Re: FortisBC Energy Inc. (FEI)

Application for a Certificate of Public Convenience and Necessity (CPCN) for Approval of the Interior Transmission System Transmission Integrity Management Capabilities Project (Application)

Response to the Residential Consumer Intervener Association (RCIA) Information Request (IR) No. 3

1 **Figure 1: Gas Transmission Miles Inspected by ILI Crack Tool - HCA and Non-HCA, US PHMSA-**
 2 **Regulated**

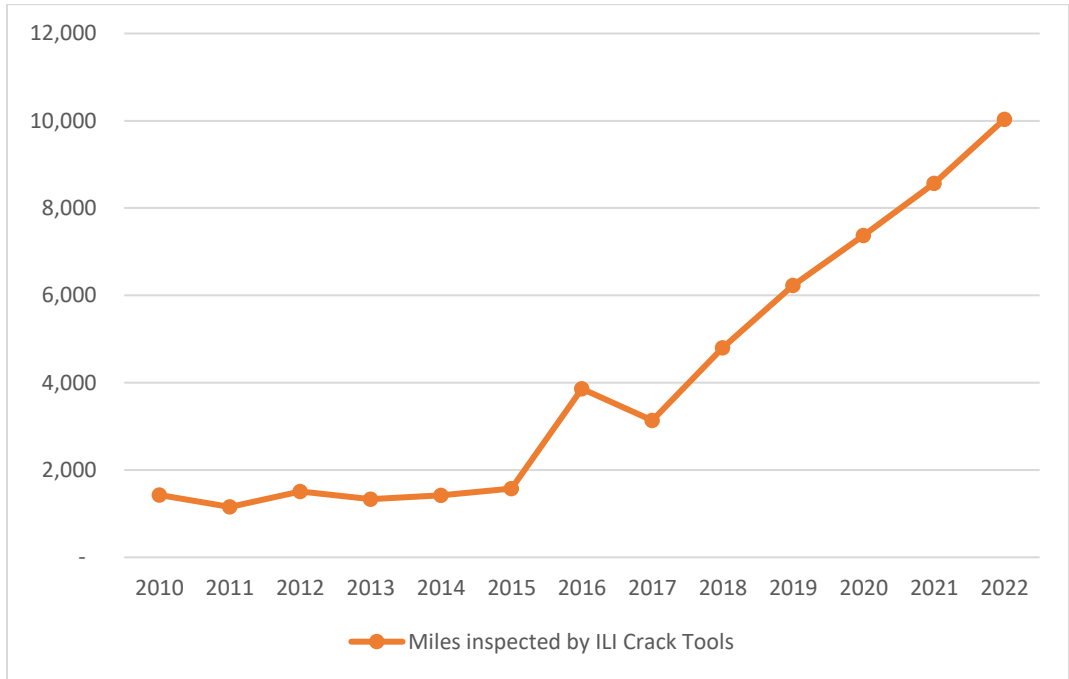
1
2 26.2 Please provide evidence that industry adoption of EMAT ILI is causing delays to
3 reporting timelines.

6 FEI's statement that industry adoption of EMAT ILI tools continues to increase and that vendor
7 capacity is becoming increasingly constrained is based on the following:

- 8 1. **Increased Industry Adoption of EMAT ILI:** Publicly available data published by the US
9 Department of Transportation, Pipeline and Hazardous Materials Safety Administration
10 demonstrates increased adoption of EMAT ILI tools.² FEI has provided the number of gas
11 transmission miles inspected by EMAT ILI tools (or ILI crack tools) in Table 1 and Figure
12 1 below for the period from 2010 to 2022 period.
